DATE RECEIVED		PERMIT NUMBER	ACT / 007 / 034
Title of Proposal:	Newly Formatted Plan	PERMIT CHANGE #	94 C
Description:		PERMITTEE	Soldier Creek Coal Co.
		MINE NAME	Banning Loadout

Re: Response to Review of Newly Formatted Plan, Soldier Creek Coal Company, Banning Siding Loadout, ACT/007/034, Folder #3, Carbon County, Utah

Re: Review of Newly Formatted Plan, Soldier Creek Coal Company, Banning Siding Loadout, ACT/007/034, Folder #3, Carbon County, Utah

REVIEW OF REFORMATTED PLAN

Fig. 4-18. Inlet control nomograph for corrugated steel pipe culverts. The manufacturers recommend keeping HW/D to a maximum of 1.5 and preferably to no more than 1.0.

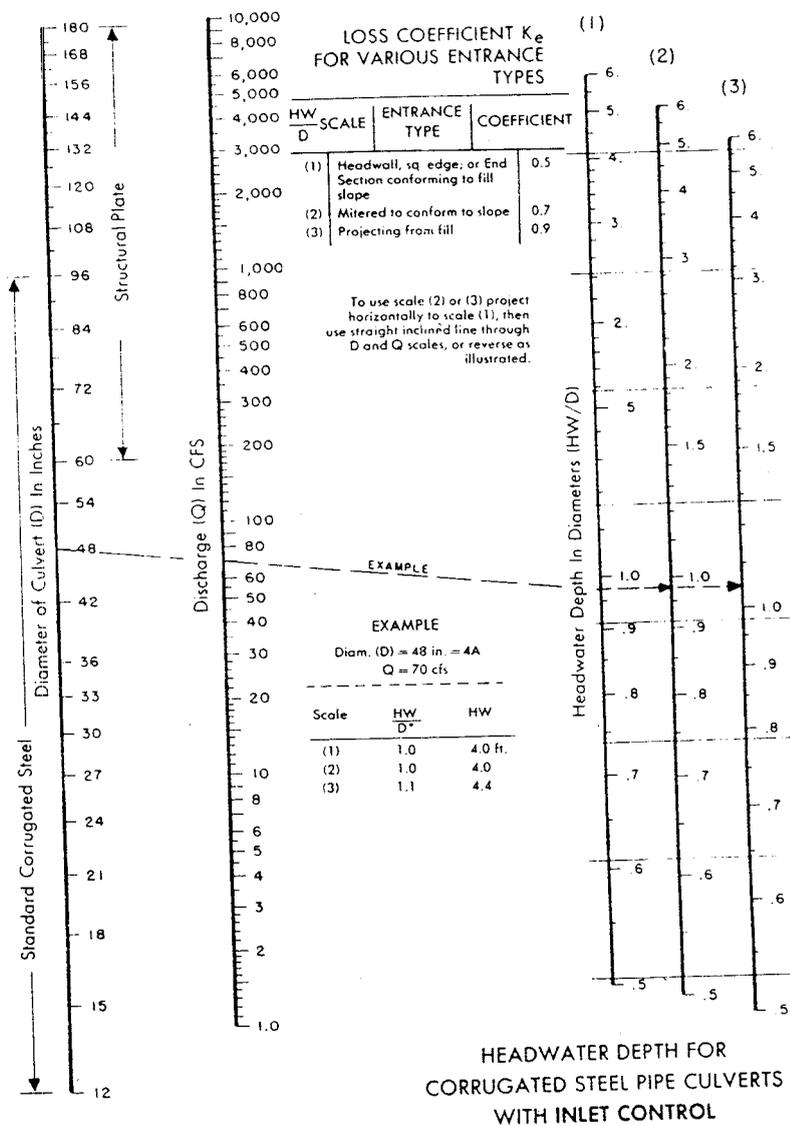
Response Designs for the haul road and culverts were submitted to the Division in January 28, 1993, and were subsequently approved. However, it is hereby proposed that the culvert designs be inserted into the permit as Appendix 5-3. To facilitate this page 5-58 has been revised to refer to Appendix 5-3, the table of contents for Chapter 5 Exhibits and Appendices has been revised to include Appendix 5-3, and a copy of the culvert design calculations are attached hereto.

The maximum flow to each of the three culverts No. 3 - 24", No. 2 - 36" and No. 1 - 48" are well within the limits of the culverts. See attach nomograph from the "Handbook of Steel Drainage & Highway Construction Products".
